**ADDENDUM NO. 2**

DATE: January 31, 2024

PROJECT: Benton Washington Regional Public Water Authority
Phase 1A – Water Treatment Plant Improvements – High Service Pump Station
Rogers, ArkansasBID DATE: February 21, 2024 at 2:00PM

JOB NO.	2124
SHEET NO.	C2

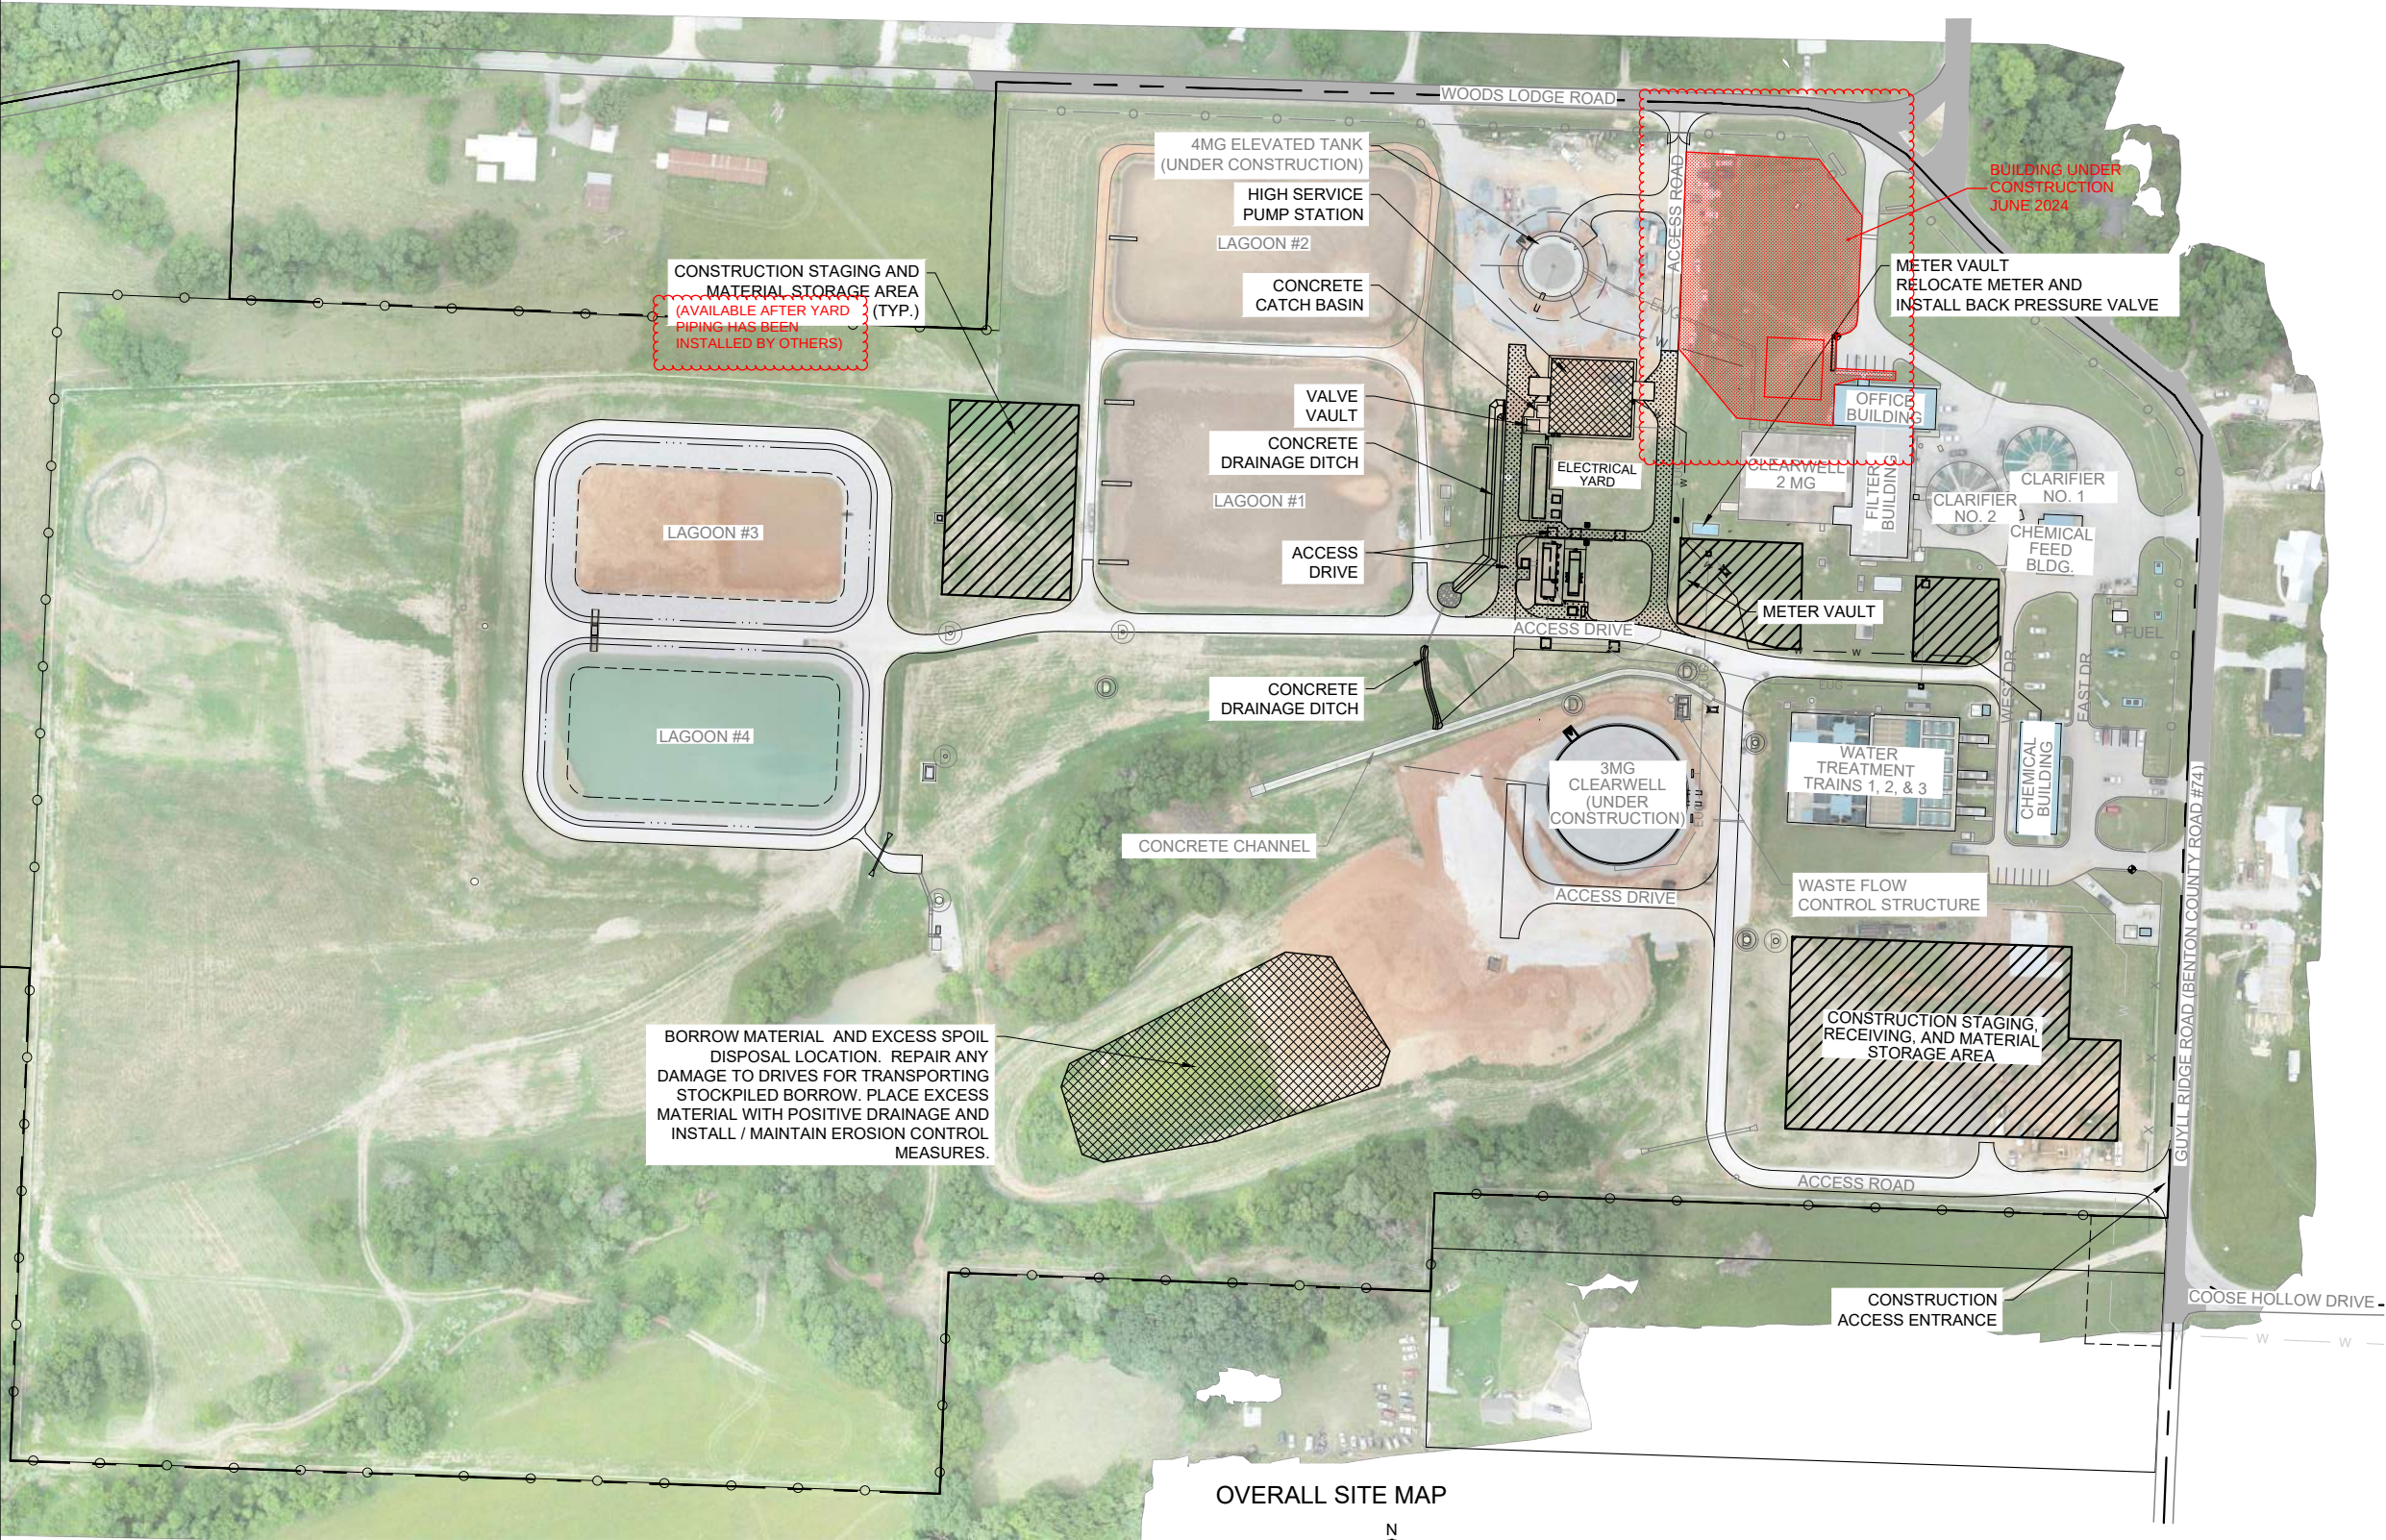
REV. NO.	DATE	DRWN	CHKD	REMARKS
1	1-31-24	CEI	JDM	ADDENDUM NO. 2, MODIFY STAGING NOTE AND ADD FUTURE CONSTRUCTION AT SITE

JOB NO.
2124
SHEET NO.
C5

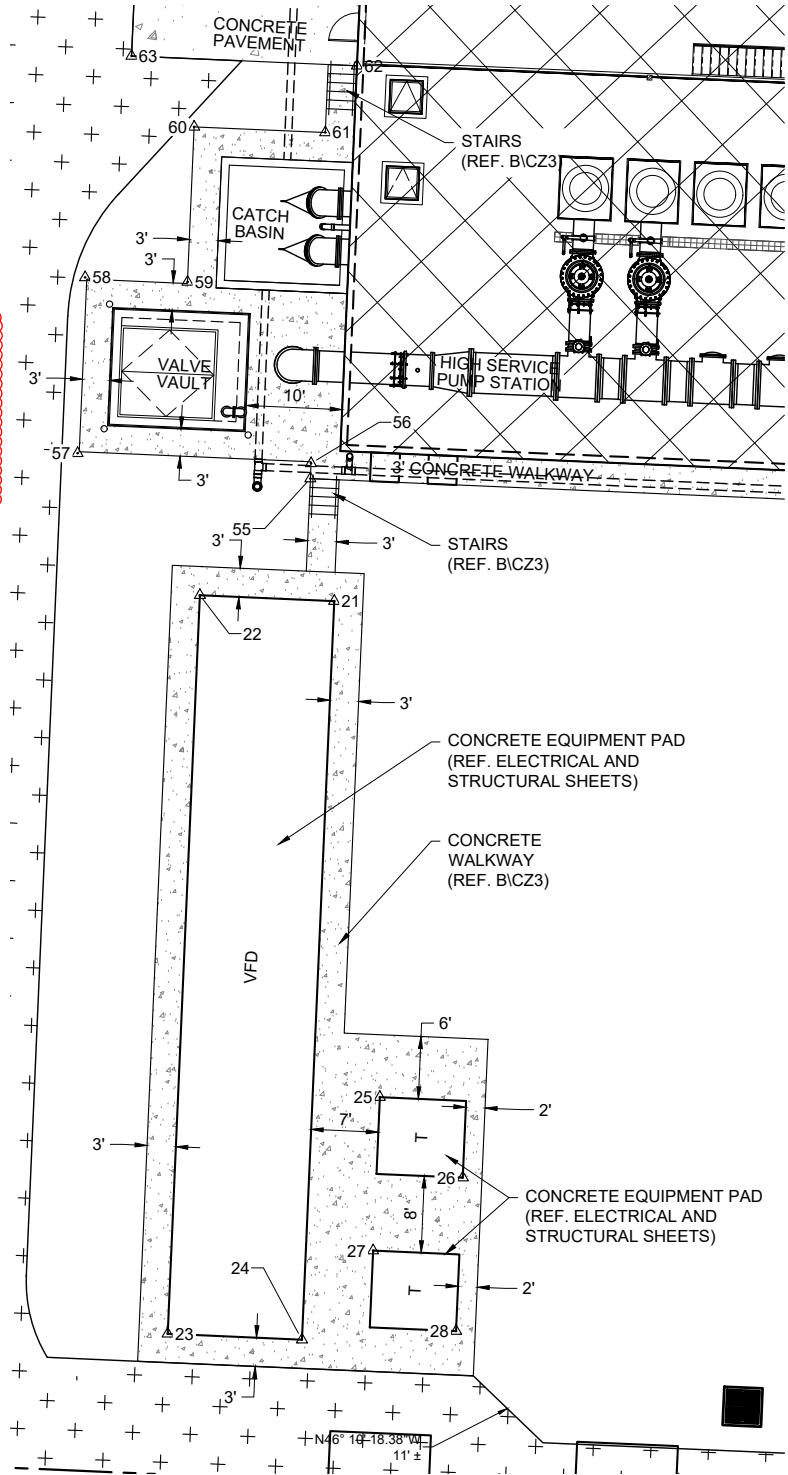
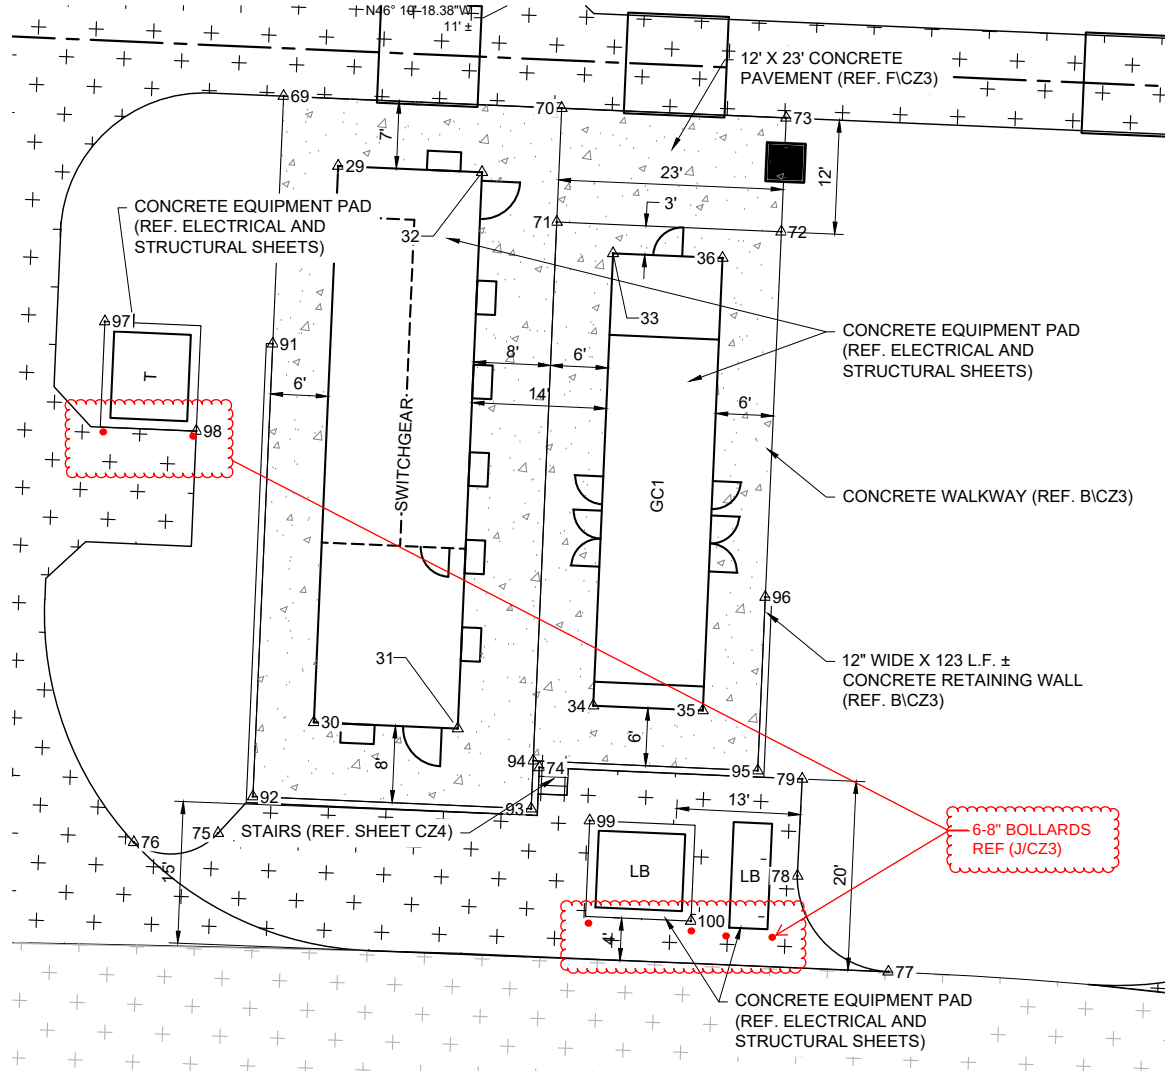
REV. NO.	DATE	DRWN	CHKD	REMARKS
1	1-31-24	CEI	JDM	ADDENDUM NO. 2, ADD BOLLARDS AND VALVE COLLAR

ROGERS, ARKANSAS	JOB NO.
CAPITAL IMPROVEMENTS PLAN PHASE IA WATER TREATMENT PLANT IMPROVEMENTS	2124
CONSTRUCTION DOCUMENTS HIGH SERVICE PUMP STATION SITE GRADING AND DRAINAGE PLAN	SHEET NO.
	C6

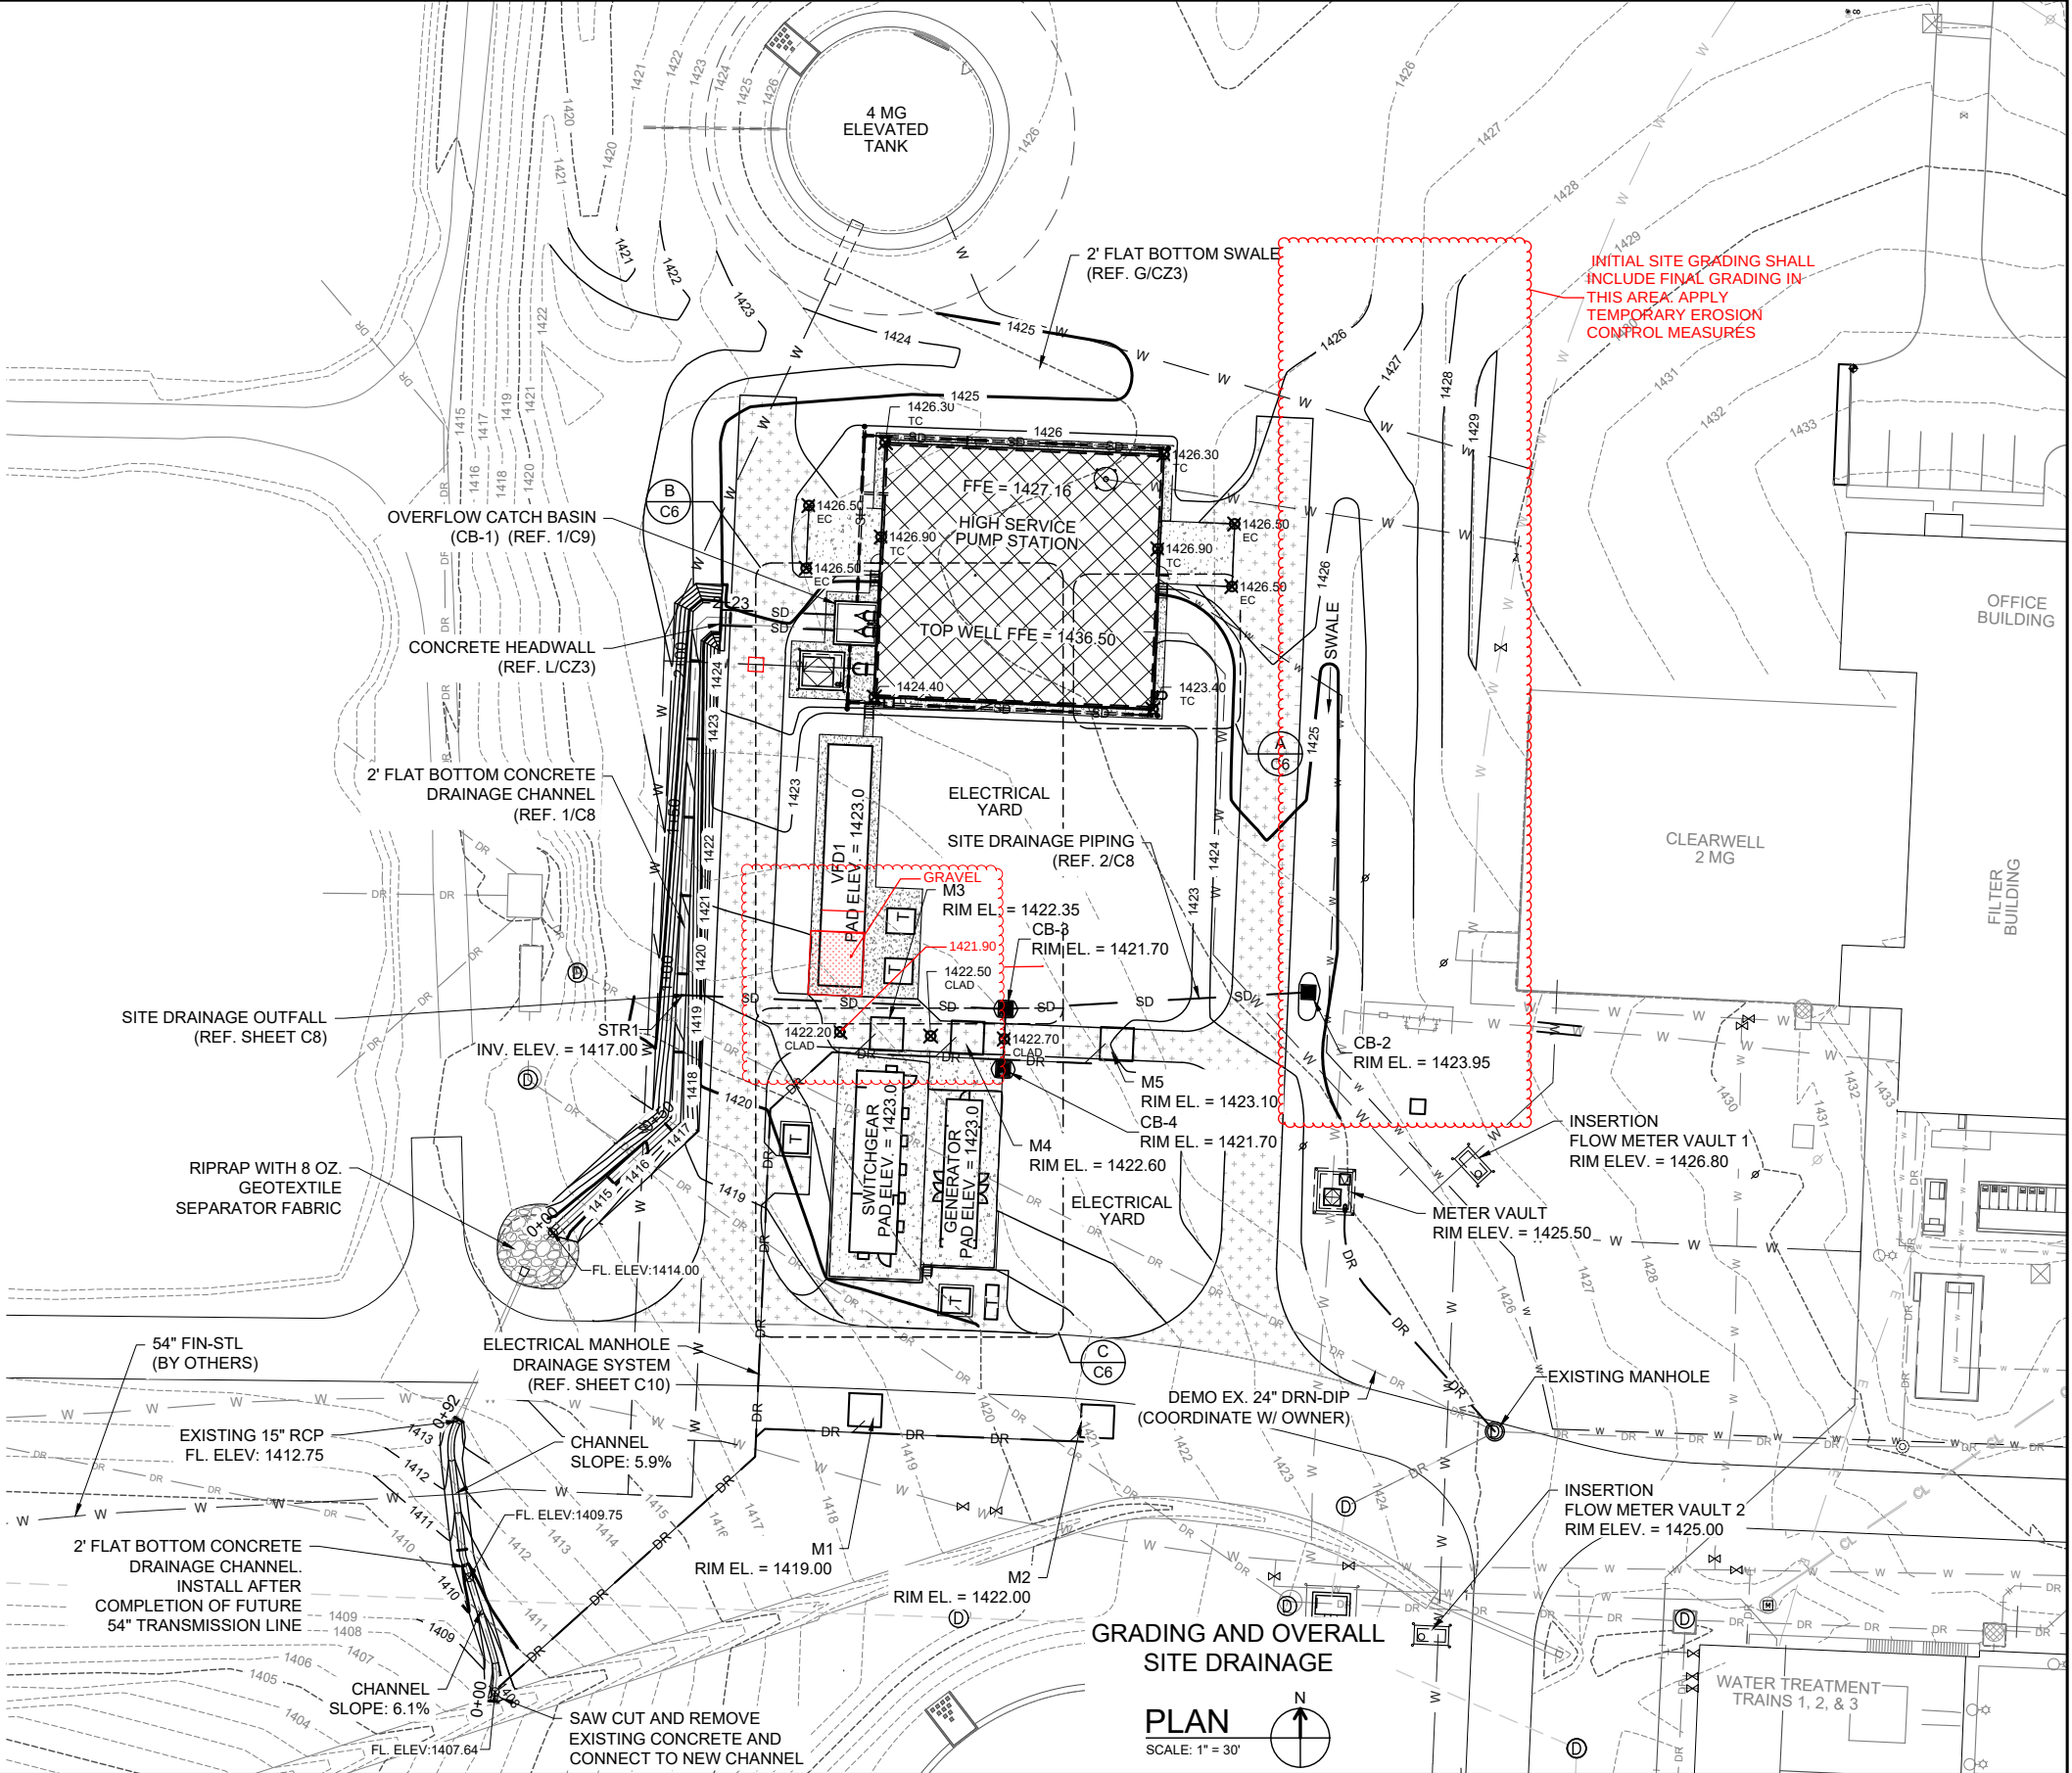
REV. NO.	DATE	DRWN	CHKD	REMARKS
1	1-31-24	CEI	JDM	ADDENDUM NO. 2, MODIFY GRADES AND GRADING PRIORITIES
